SUBDIVISION COMMITTEE
METROPOLITAN AREA PLANNING COMMISSION

STAFF REPORT
(Final Plat; Preliminary Plat Approved 8/24/89)

CASE NUMBER: S/D 89-51 - COLEMAN ADDITION

LOCATION: S.E. corner of K-42 and MacArthur Road Intersection

VICINITY MAP:

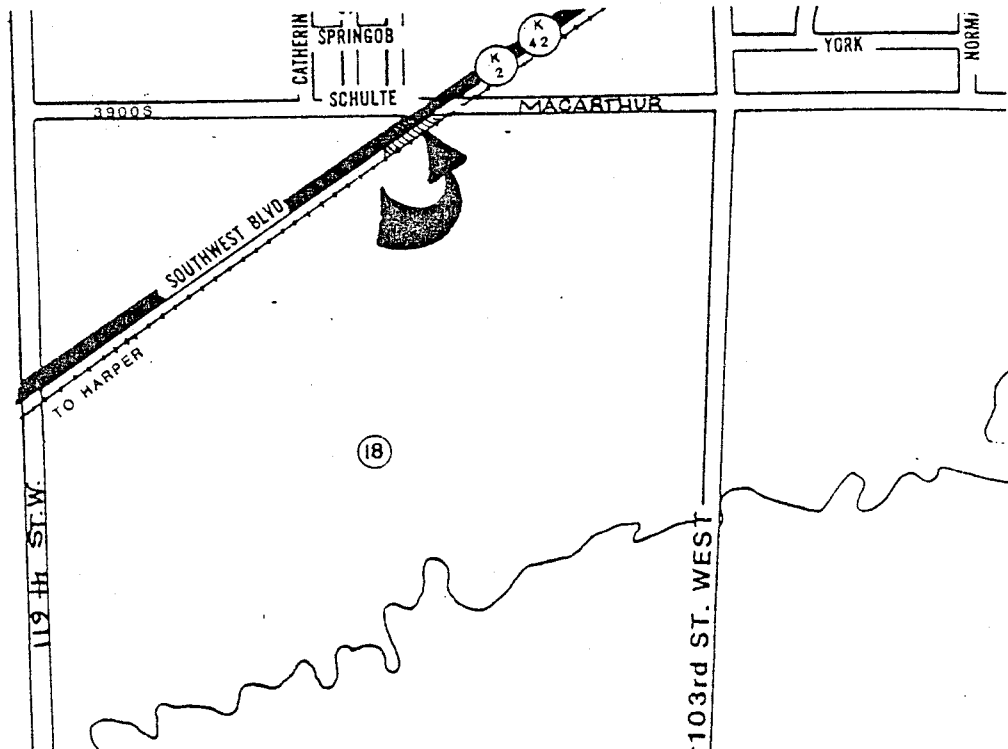
- A. Since neither municipal water nor sanitary sewer is available to serve this property, the applicant shall contact the Environmental Health Division of the Health Department to find out what tests may be necessary and what standards are to be met for approval of on-site sewerage facilities and water wells. A memorandum shall be obtained specifying approval. The applicant is advised that depending on right-of-way requirements, limited space may be such that on site facilities may require a variance of Health Department standards to obtain approval for well and septic systems at this site. As indicated by this final plat, this site is just over 32,000 sq. ft, which will require a variance for on site facilities.

- D. Since this plat is not dedicating right-of-way for the proposed realignment of MacArthur, the final plat tracing shall clearly indicate this. "Proposed" shall be indicated on the face of the plat where the note "MacArthur Road Right-of-Way" is shown. Also, another note shall be placed in this same general area of the plat which indicates "This right-of-way is not being dedicated by this plat."

- E. The plattor's text shall be amended, where reference is made to access controls to the realigned MacArthur Road, by inserting "proposed" before each reference to MacArthur Road.

- F. The last paragraph of the plattor's text, where reference is made to the contingent dedication shall be amended by adding "the Northwesterly line of: before the two references to "lot 1" which follows the description of access across the Northeasterly 40-feet of . . .

- G. On the face of the plat "C.A.C." shall be shown in the area of the Contingent access control. This abbreviation shall also be defined in a legend located below the north arrow.

- K. If the drainage plan for this site indicates that drainage will occur to the Atchison, Topeka, & Santa Fe Railroad right-of-way to the southeast of this plat, the applicant shall provide a letter from this railroad indicating its willingness to accept such drainage.

VICINITY MAP:

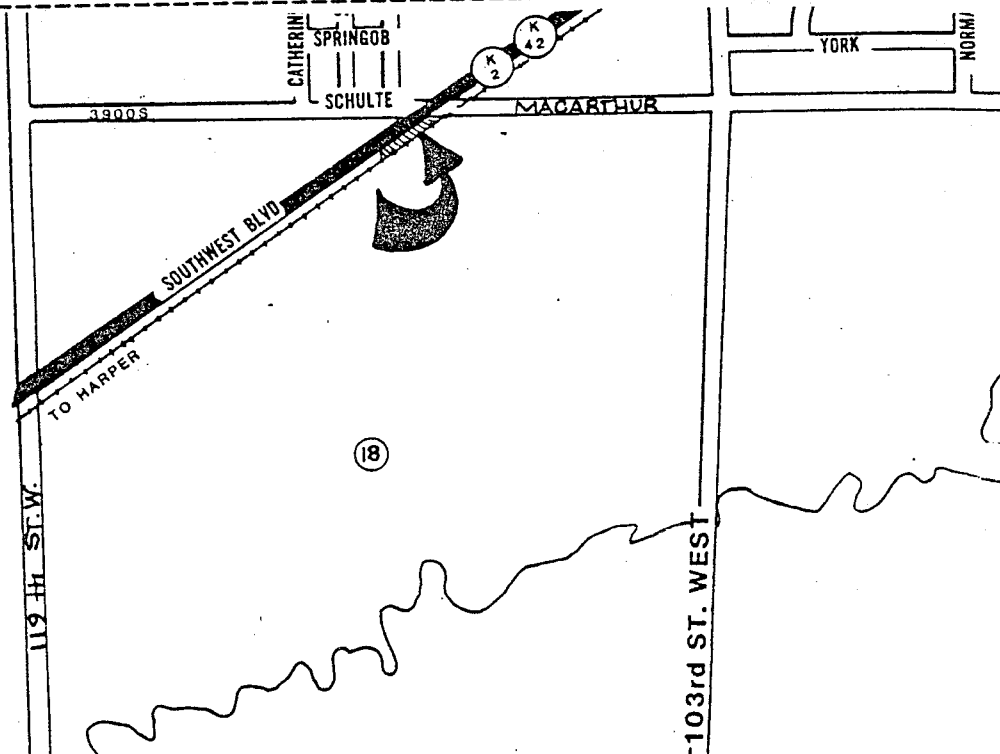
- D. Unless this property has access and utilizes a municipal water supply, a minimum lot size of 40,000 square feet would be needed for on site water, and, if tests are acceptable, a septic system. Since the total size of this site is approximately 1-acre it cannot at this time be platted into more than a 1-lot plat. The final plat shall therefore indicate only one lot.

- E. The subdivision regulations require, for intersections of major arterials, the dedication of 75-feet of half street right-of-way for a distance of 250-feet from the intersection of the center lines of such arterials. This right-of-way is to taper to the standard right-of-way of 50-feet of half street (60-feet for FAS can be such as MacArthur) over the next 100-feet, or 350-feet from the intersection of the center lines.

Because of safety, the County is considering a realignment of this intersection, that could shift MacArthur and consequently the intersection, south of this site. County Engineering should be prepared to indicate if at this time an outright or contingent dedication of major intersection right-of-way is desired or if the dedications indicated on this plat are acceptable as is.
- F. County Engineering should also be prepared to indicate any access controls it feels should be required. In particular it can be noted that complete access control is typically required within 150-feet of the center line of a railroad track. Complete access control is also presently required for a distance of at least 40-feet along either side of a lot back from the intersection of two major arterials.

Under these conditions no access should be provided to MacArthur across the north line of this plat and the drive to K-42 at the north west corner of the plat should be closed. In addition complete access control further back than the 40-feet indicated above has been typically requested and is being proposed in the revision to the subdivision regulations. County Engineering, therefore, needs to indicate their positions on access controls for this site.

- G. The final plat shall indicate a 35-foot building setback to both MacArthur and K-42.
- H. The applicant shall submit an avigational easement covering all of subject plat and a restrictive covenant assuring that adequate construction methods will be used to minimize the effects of noise pollution in the habitable structures constructed on subject property.
